**MANDATORY**  
**SERVICE BULLETIN**

**No. 0002**

**SUBJECT:** Replacement of Duplicating Link @ STN 4

**MODELS AFFECTED:** Serial Numbers Affected:  
SE5A WA18  
WA19  
WA20

### PART IDENTIFICATION:

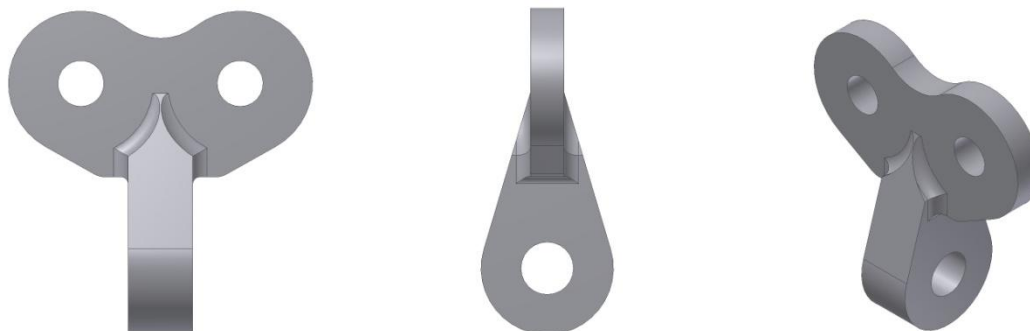
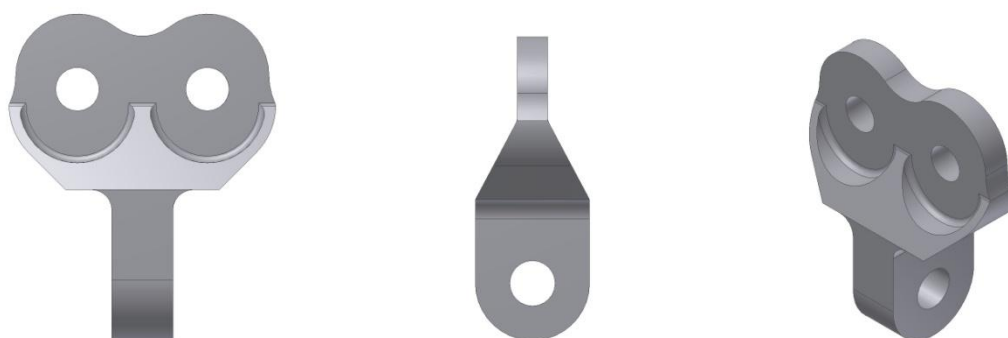
**PURPOSE:** Duplicating link W1S010073 transfers flight loads from the upper wing via a bracket at the junction of the strut and main spar. Two streamlined flying wires carry the load to an attachment bracket at the junction of the lower wing main spar and the fuselage. To increase the safety factor in the event that one of the streamlined flying wires fails, the fitting has been redesigned and manufactured from equivalent steel to RAF spec 6A.

**COMPLIANCE:** Replacement of duplicating link W1S010073 with duplicating link **W1S070030** by using the instructions described below will ensure full compliance with this service bulletin.

1. Order and install Duplicating Link @ STN 4 P/N W1S070030 to replace existing Duplicating Link P/N W1S010073.

Part No. W1S010073

Part No. W1S070030
